**Comments of the Sierra Club, *et. al.*, to the Department of State on the Draft  
Supplemental Environmental Impact Statement for the TransCanada Keystone  
XL Pipeline**

Submitted April 22, 2013

Via electronic and U.S. mail to:  
U.S. Department of State  
Attn: Genevieve Walker, NEPA Coordinator  
2201 C Street NW  
Room 2726  
Washington, DC 20520

*Figure 1.*

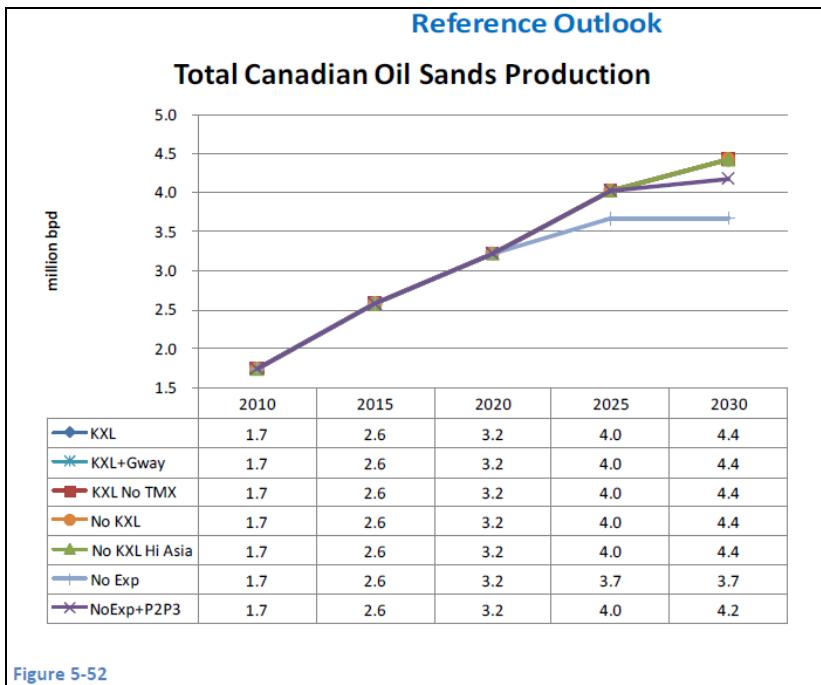
The graphs on page 8 of the EnSys Report illustrate this projected under different demand scenarios. (Reproduced as figures 1 and 2 below.). Figure 4 (showing the Reference Outlook) and Figure 5 (showing the Low Demand Outlook), both shown below, show a stark difference in production levels if Keystone XL were built versus if it were not built. Together, the graphs show that Keystone XL is expected to increase tar sands production by 750,000 to 900,000 bpd.

*Figure 4. Source: State Department draft SEIS for Keystone XL, 1.4-53.*

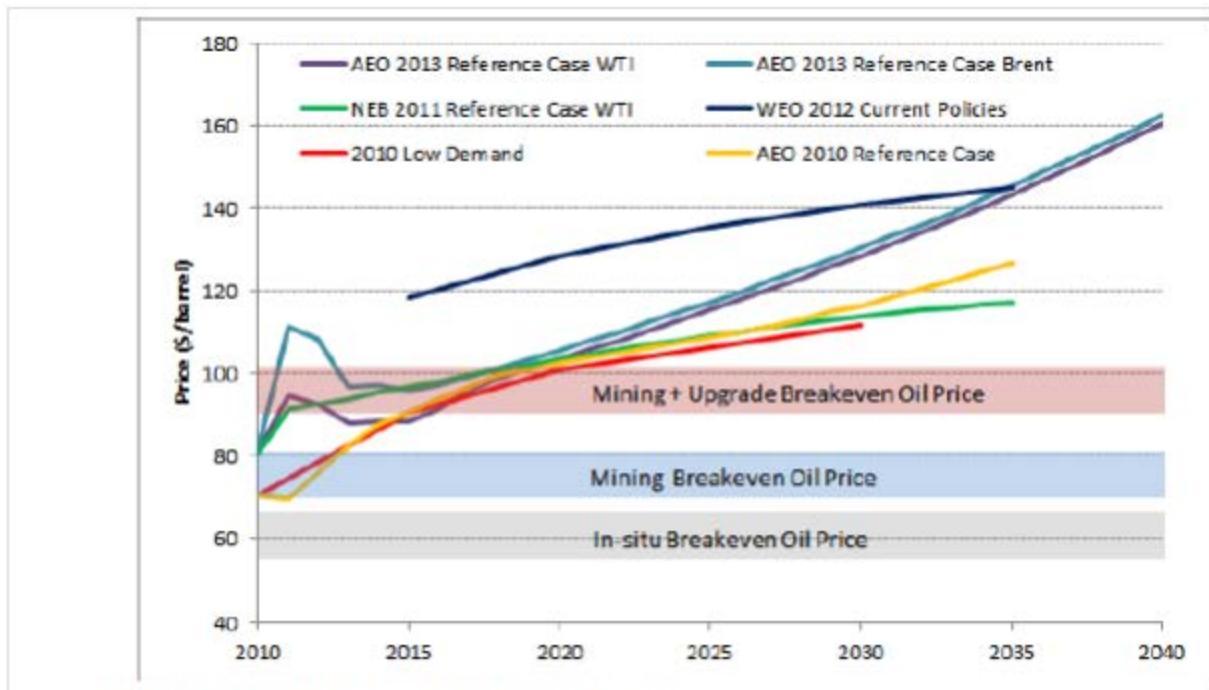
The DSEIS conclusion that rail is an economically feasible option is also based on a fundamental flaw in its analysis of the long term profitability of tar sands production. While the DSEIS acknowledged that many new tar sands projects are economically challenged, it assumed that oil prices would increase through 2035 and concluded that if production costs stay constant, new tar sands projects would be able to bear slightly higher transport costs.<sup>169</sup> The State Department expresses this argument in the graph below in which it adds its low estimate of the cost difference between rail and pipeline to NEB's 2011 breakeven price and assumes that these new production costs will stay constant through 2040.

**FIGURE 3.1**  
**INCIDENT COMMAND SYSTEM**

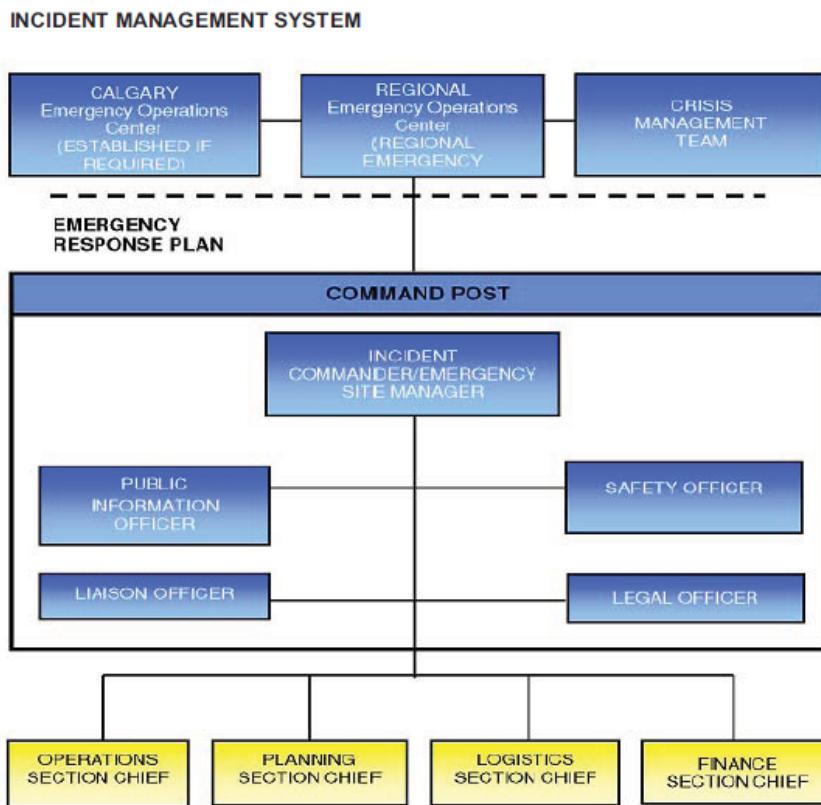
As can be seen, with the exception of the word “Calgary” in the upper left-hand box, the rest of the schematic could apply to nearly any incident command structure for any facility anywhere. The personnel job descriptions are also entirely generic and appear to be contractor boilerplate and include no project or geographically specific directions.

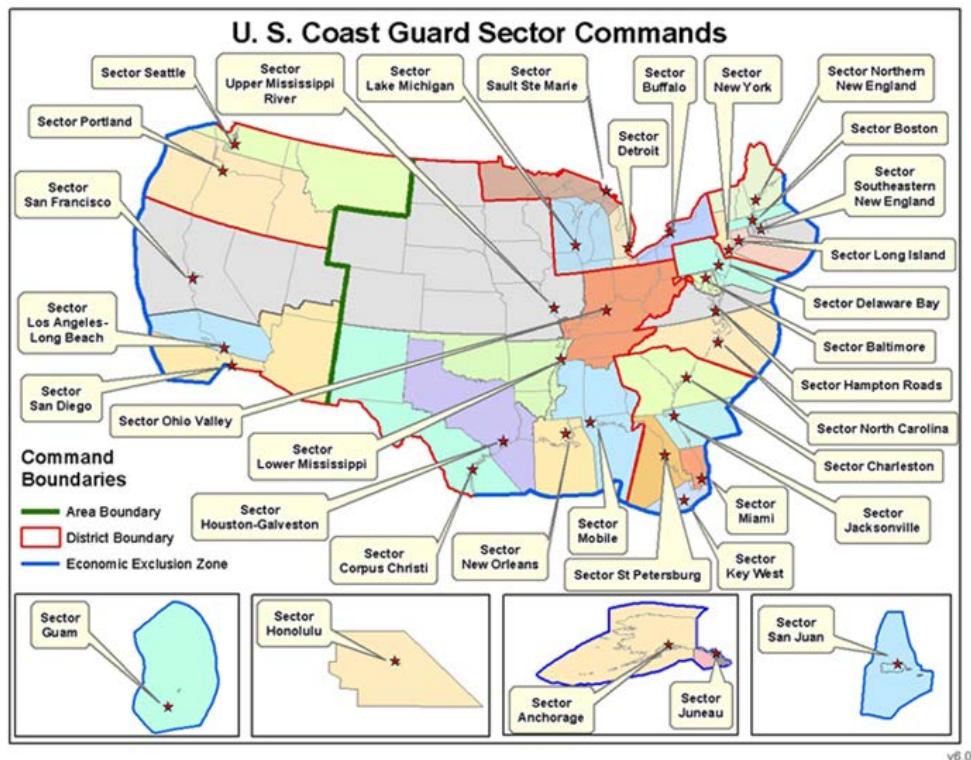
The two other zones identified in the App. I ERP are likely Canadian Zones. Therefore, the App. I ERP does not include spill response commitments for KXL. In addition, TransCanada maintains one smaller trailer per response zone containing primarily oil spill boom. As detailed in the Great Plains at Risk report, for each response zone, the major equipment acquired by TransCanada includes: one response trailer, one boom trailer (together the trailers contain 2,000 feet of different types of boom), two boats, 298 bbls of temporary storage capacity, and two skimmers. TransCanada has not identified the locations of the tow vehicles for these trailer or related response personnel, even though the location of a tow vehicle and personnel at the time of a spill can significantly impact how quickly a trailer can arrive at a spill site.
